**SITE INVESTIGATION WORK PLAN ADDENDUM FOR SCOT INDUSTRIES, INC.  
1532 WEST GALENA STREET, MILWAUKEE, WISCONSIN  
WDNR BRRTS NO. 02-41-587342 (VPLE NO. 06-41-590344)**

The objective of this SIWP Addendum is to address the comments from the Wisconsin Department of Natural Resources (WDNR) presented in the letter dated September 8, 2022, entitled "Review of NR 716 Site Investigation Report – Scot Industries, Inc."

**FIGURE 02**

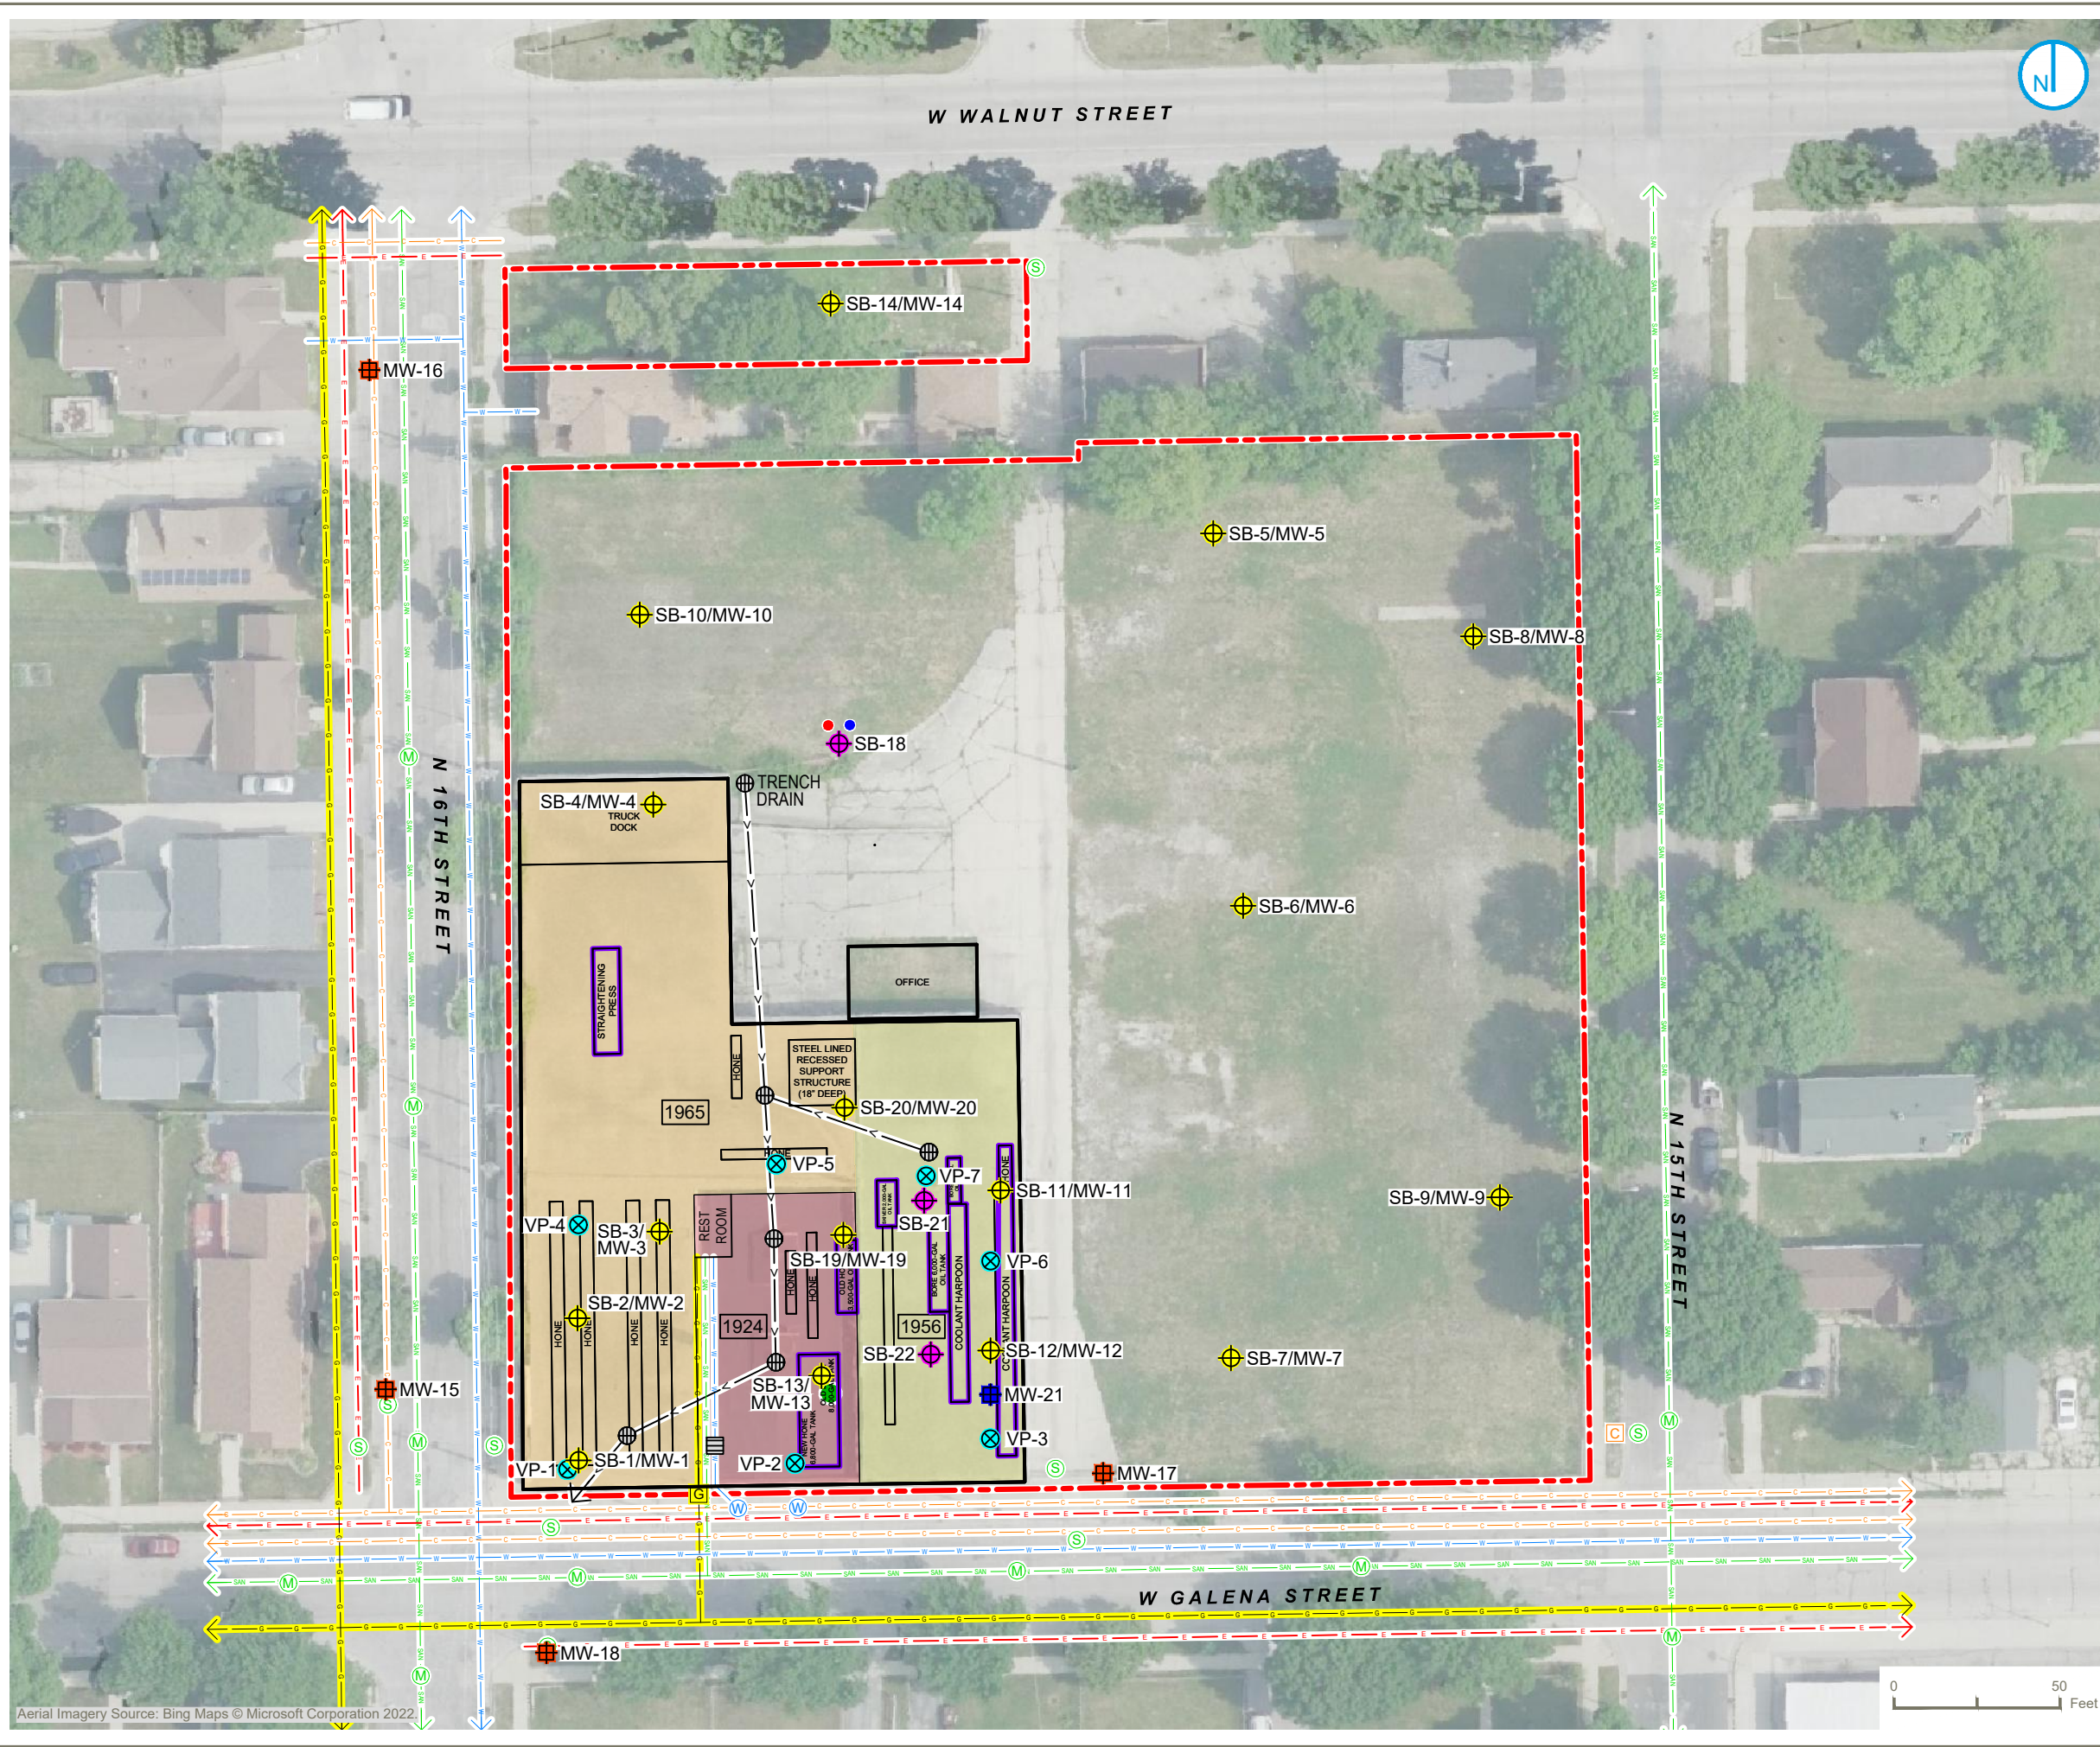
One round of vapor sampling was conducted during the site investigation. WDNR's guidance publication RR-800 recommends conducting a minimum of two rounds of sampling to evaluate sub-slab vapor. An additional vapor point is recommended between SB-11 and SB-19 to evaluate sub-slab vapor conditions where TCE and other CVOCs were detected in soil and groundwater. Because of the low levels currently detected, the sub-slab vapor result from the new vapor pin will be evaluated to determine whether a second round of sub-slab vapor sampling is needed.

1. Light non-aqueous phase liquid (LNAPL), or free product, measured at monitoring well MW-12 was identified as lubricating oil (honing oil). The oil source needs to be identified and the extent of the LNAPL needs to be delineated to the south based on the assumed direction of groundwater flow.

**Response:** An additional sub-slab vapor pin (VP-7) was installed near the area of soil boring SB-21 as depicted on Figure 2. The vapor pin (VP-7) was sampled with methodologies consistent with the approved WAC NR 716 Site Investigation Work Plan dated June 17, 2021. The sub-slab vapor sample was analyzed for chlorinated VOCs using USEPA Method TO-15 (gas chromatograph/mass spectrometer). The vapor pin was left in place for the possibility of future analytical testing. The vapor analytical results from July 26, 2022, exhibited a Sub-Slab Vapor Risk Screening Level (VRSL) large commercial/industrial exceedance for trichloroethene.

In order to delineate the extent of the LNAPL to the south, Ramboll proposes to place a groundwater monitoring well between MW-12 and VP-3 at the site as depicted in Figure 2. Ramboll proposes to sample for VOCs and PAHs in this location. Ramboll proposes to conduct quarterly sampling at this location until trends are established or if no exceedances are observed, two consecutive rounds of sampling will be obtained for confirmation.
